In the matter of the Southern Link Inland Port

**STATEMENT OF EVIDENCE BY BRENDON SHANKS ON BEHALF OF SOUTHERN LINK
PROPERTY LIMITED**

Noise

19 August 2026

Figure 1: Noise monitoring data (Appendix D – Rp 001 R04 20240460)

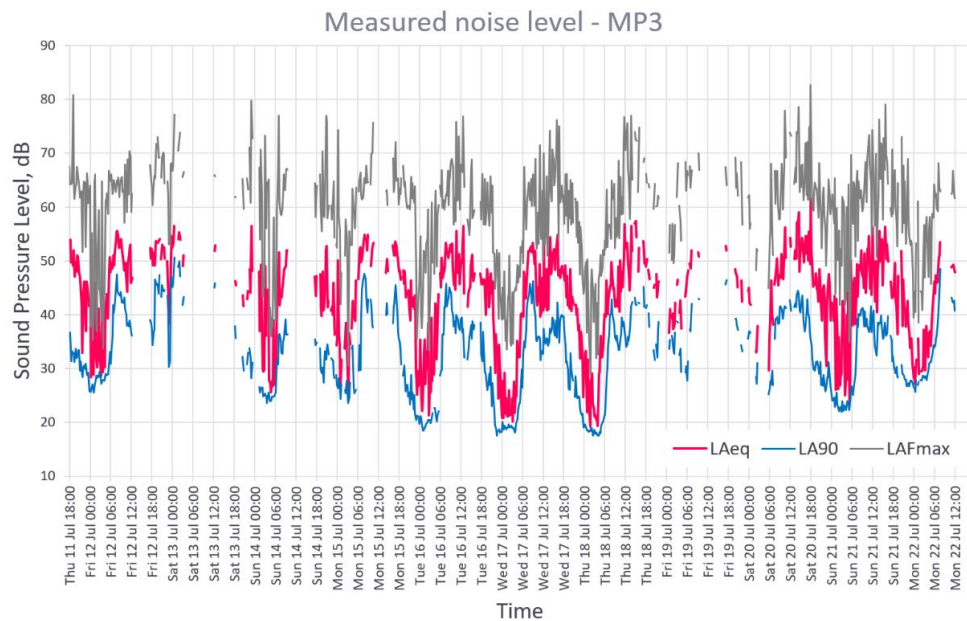
- 4.1** The comments from Brian Anderton and Karen Stewart relating to noise focus on potential effects on the horse breeding activity at the White Robe Lodge. In particular, they are concerned about sudden noises that can cause flight response in horses. They point out the sensitivity of a foaling unit which includes pens adjacent to the dwelling at 273 Dukes Road North.
- 4.2** They have identified several noise sources that they consider will generate such noise events. These include noise sources on the Site and on Dukes Road North. I have addressed the various noise sources below.

- 4.3** I have conducted noise monitoring near where the foaling unit is located (Noise Assessment Rp 001 R04 20240460 - Appendix D, Measurement Position 3). The plot in Figure 1 shows the measured noise levels during the monitoring period. The grey line indicates the L_{AFmax} noise levels. This shows that the noise environment in this area includes existing high noise events, with levels regularly above 65 dB L_{AFmax} . These are typically due to aircraft –

helicopters and planes, and vehicles on Dukes Road North – including trucks engine breaking and “boy racer” cars accelerating aggressively.
